**SUBJECT:** R.E. Ginna Nuclear Power Plant  
Docket No. 50-244

**Supplemental Response to Requests for Additional Information Regarding  
Topics Described by Letters Dated August 24, 2005 and October 28, 2005**

ATTACHMENT 2  
RESPONSES TO NRC RAIs 2, 3, 5 REGARDING POST-LOCA LONG-TERM COOLING  
OCTOBER 28, 2005

ATTACHMENT 3  
RESPONSES TO NRC RAIs REGARDING LOCA ANALYSES  
AUGUST 24, 2005

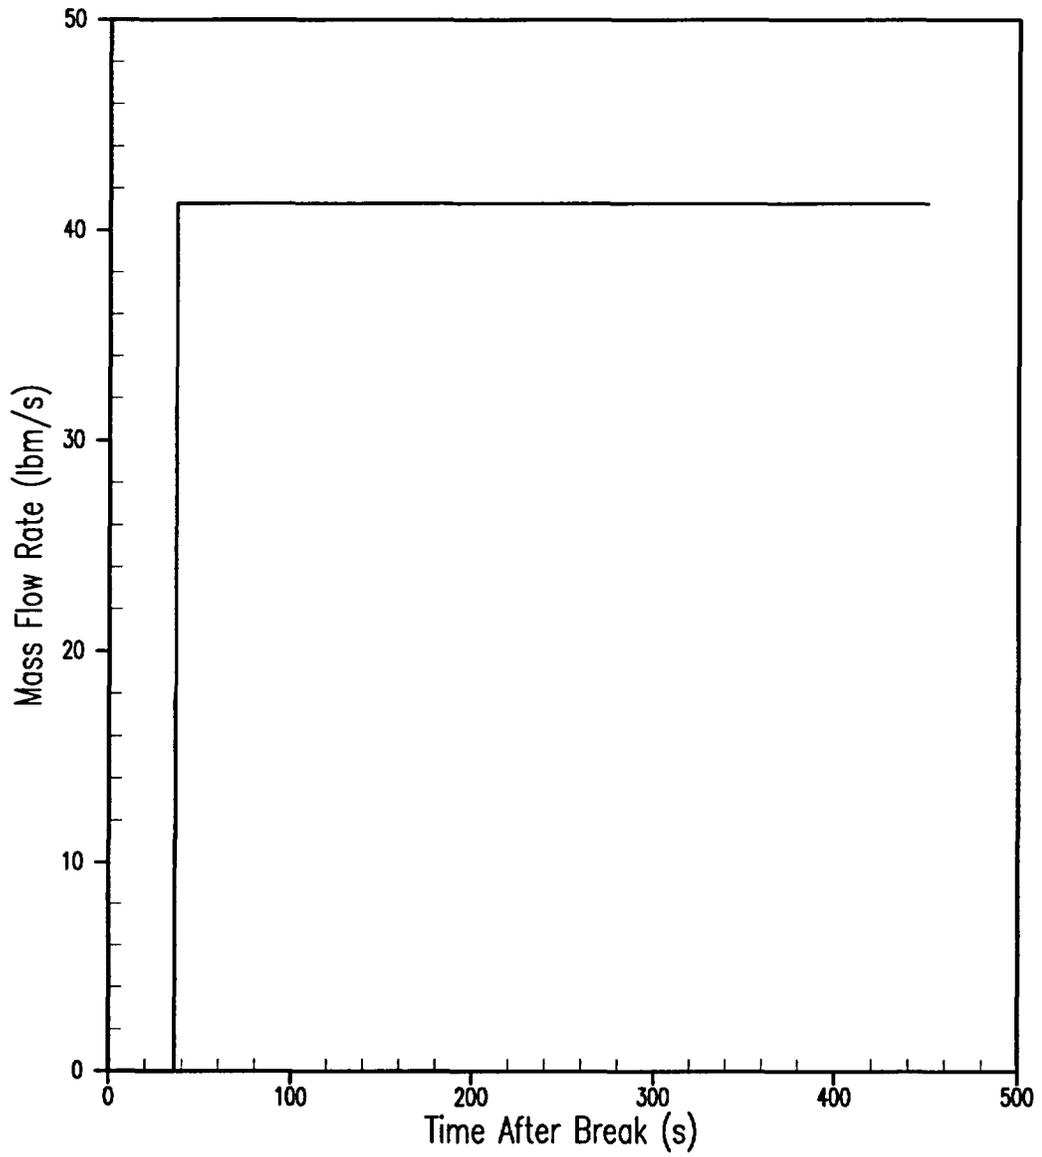
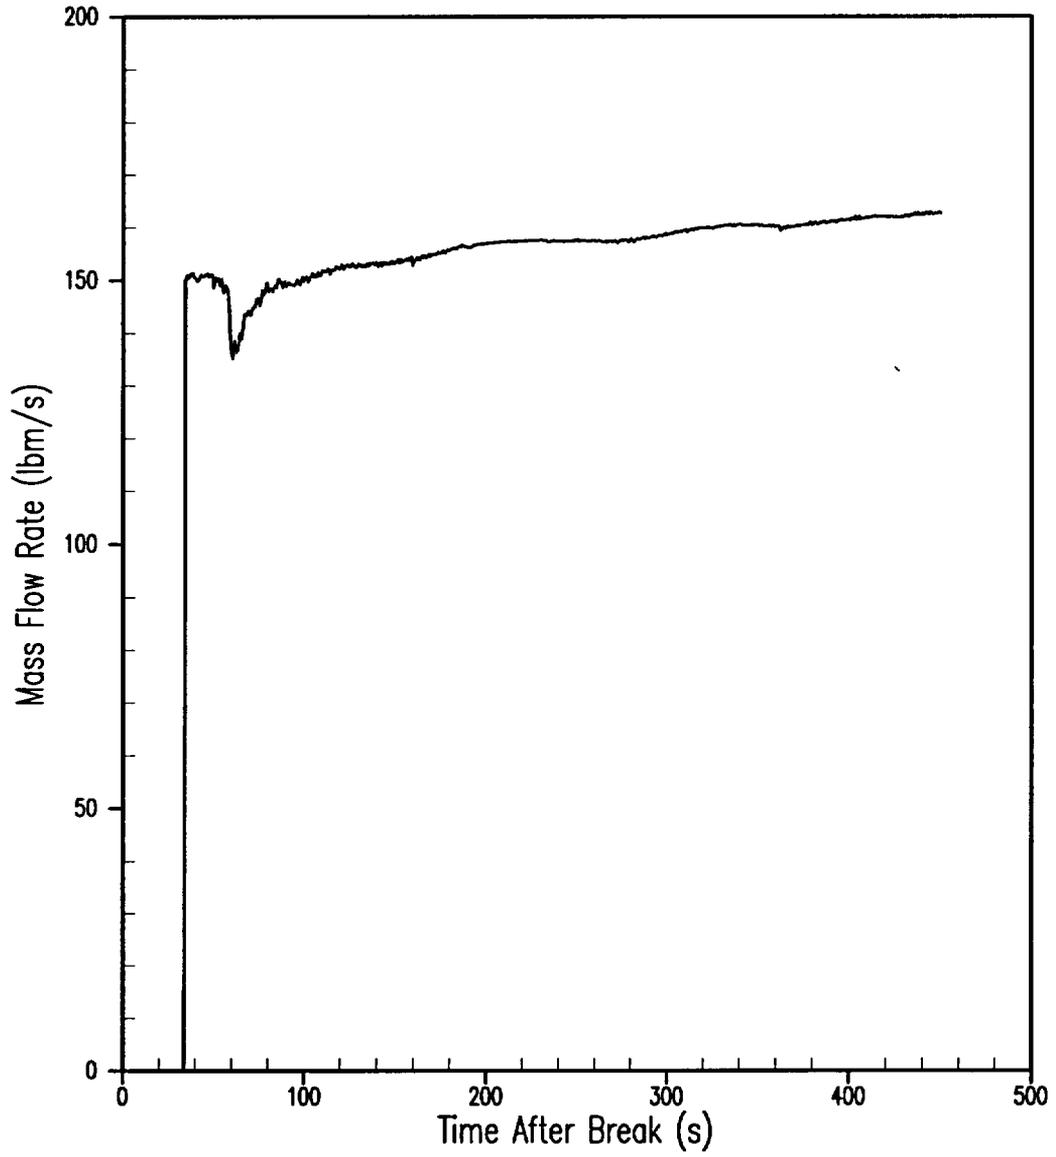
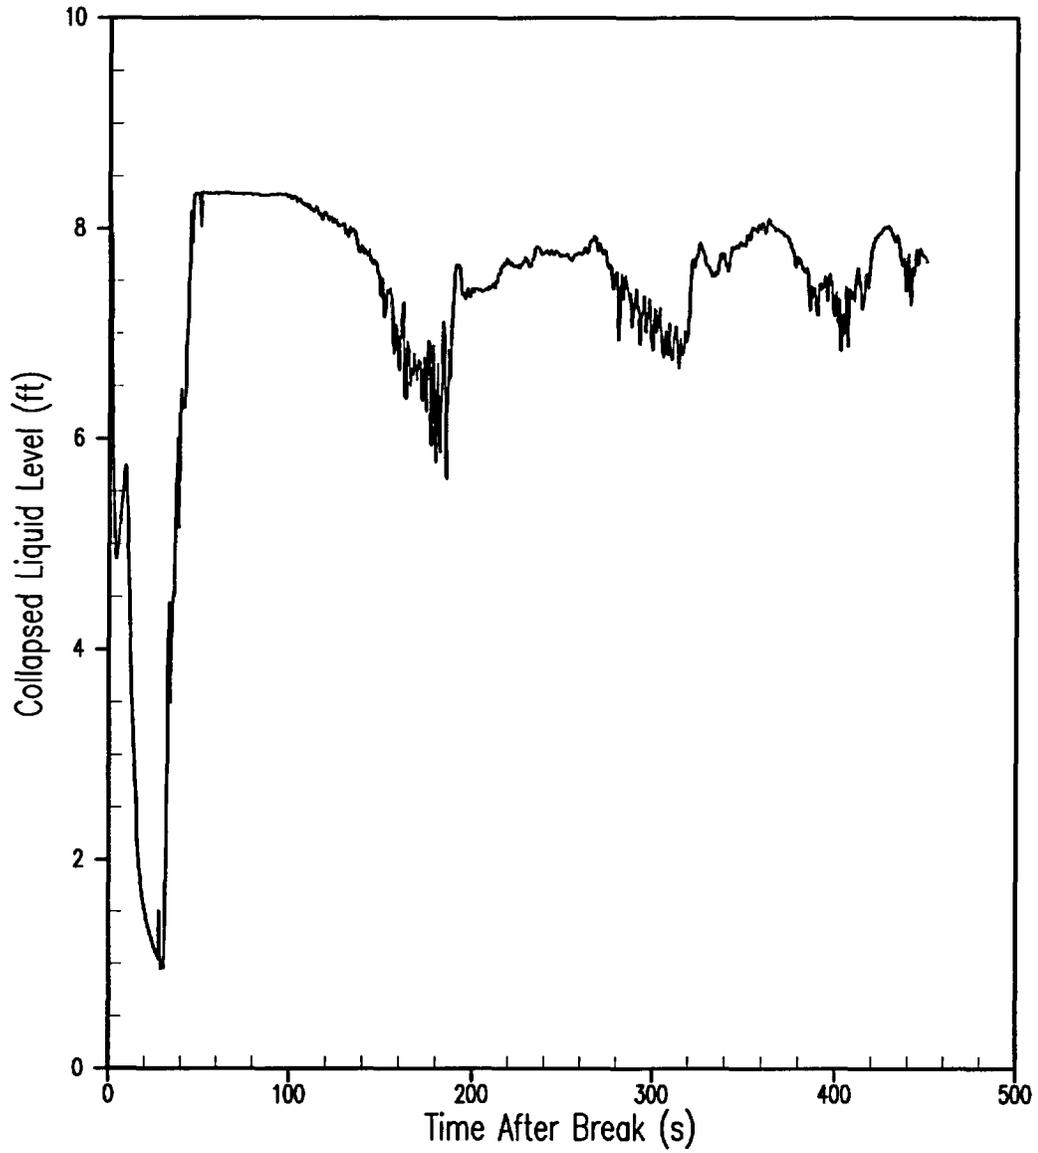
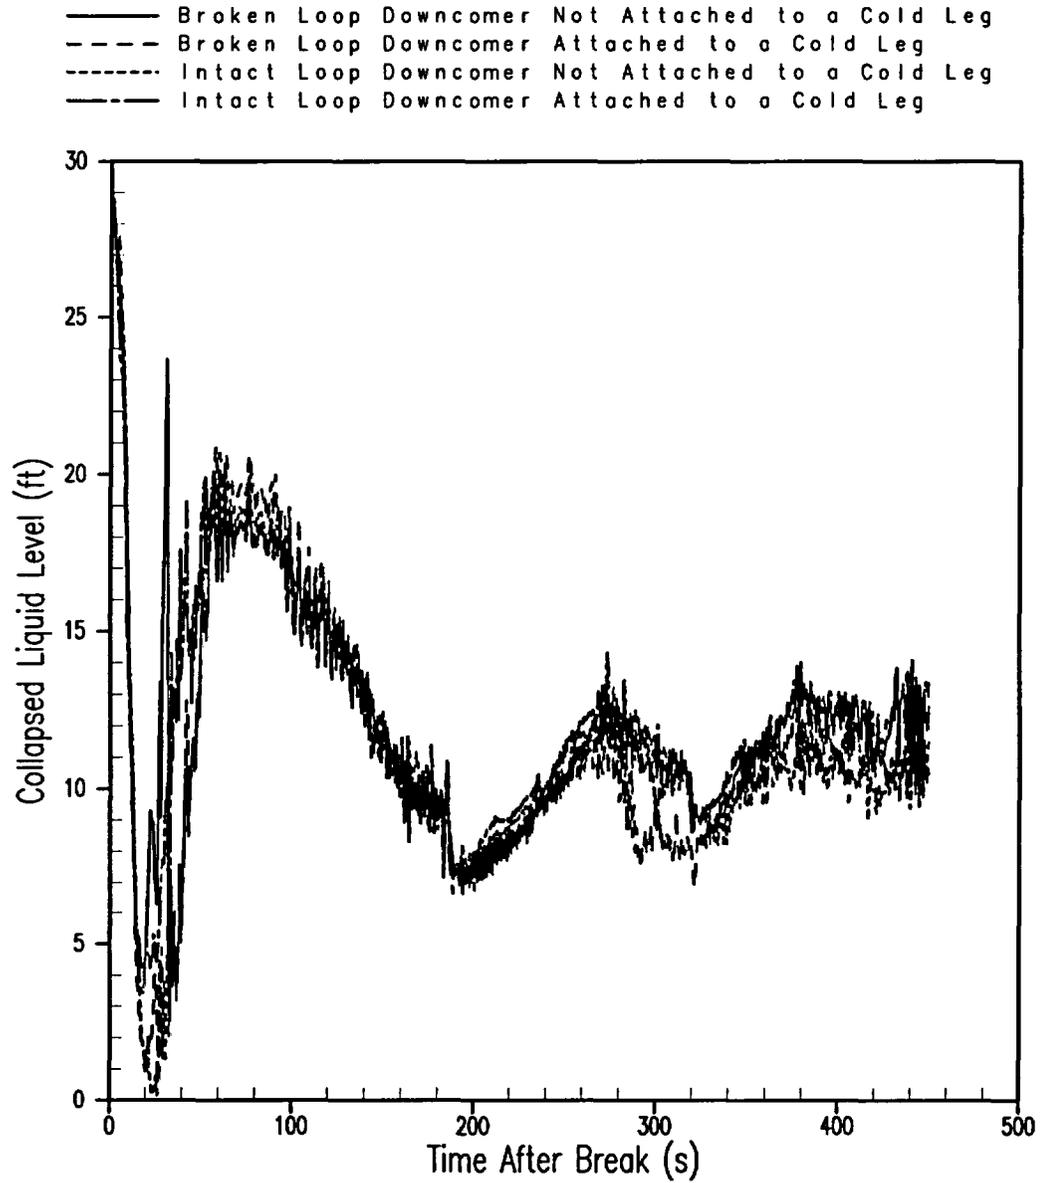
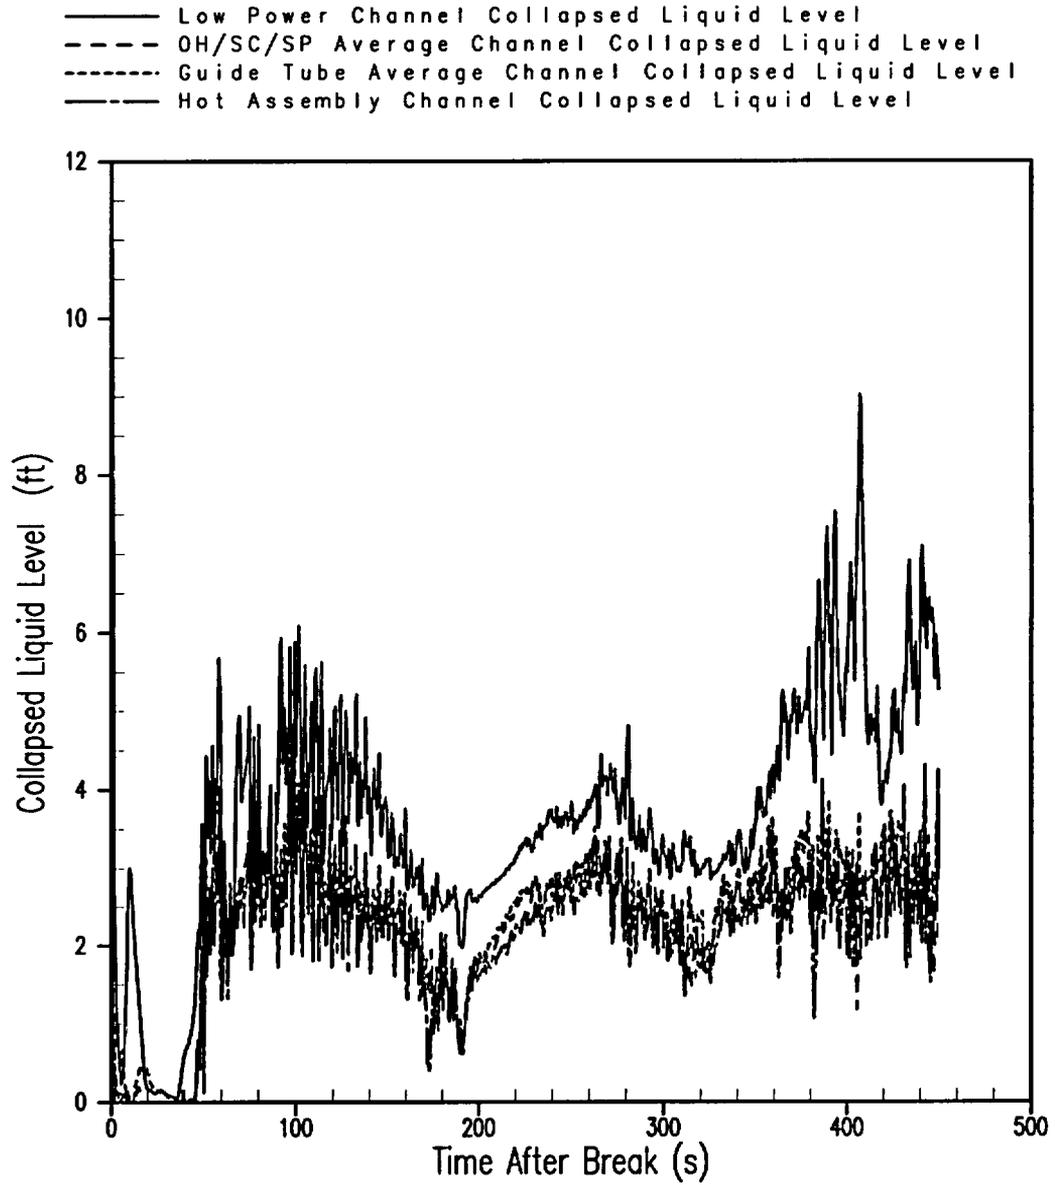
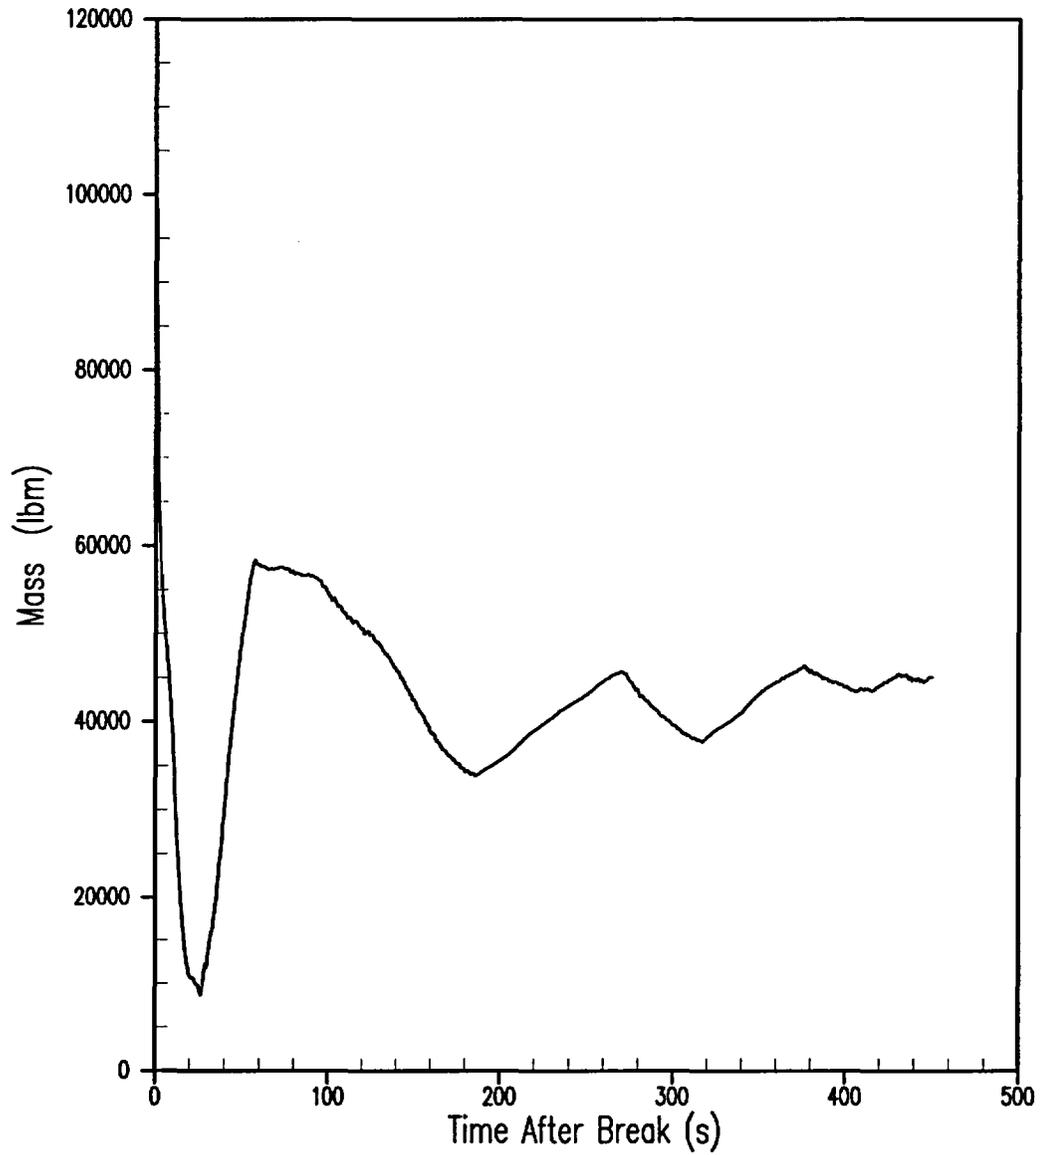
Provide the complete analysis results including all of the key major response parameters. Also, did the analysis include downcomer boiling effects and what was the worst single failure if downcomer boiling occurs? What containment pressure was assumed?

Figure 1.6 is a plot of the accumulator injection flow, Figure 1.7 a plot of the High Head Safety Injection Flow into the intact cold leg, and Figure 1.8 a plot of the Low Head Safety Injection Flow into the upper plenum. Figures 1.9, 1.10, and 1.11 are plots of the lower plenum, downcomer, and core collapsed liquid levels, respectively. The reference point for the lower plenum liquid level is the bottom of the vessel. The reference point for the downcomer liquid level is the point at which the outside of the core barrel, if extended downward, intersects with the vessel wall. The reference point for the core collapsed liquid levels is the bottom of the active fuel.

The vessel fluid inventory throughout the transient is plotted in Figure 1.12. Figure 1.13 is a plot of the Peak Clad Temperature for all 5 rods modeled in WCOBRA/TRAC, and Figure 1.14 a plot of the hot rod PCT elevation versus time. Note, the peak clad temperatures in Figure 1.13 are the WCOBRA/TRAC calculated temperatures, not the HOTSPOT calculated temperatures.
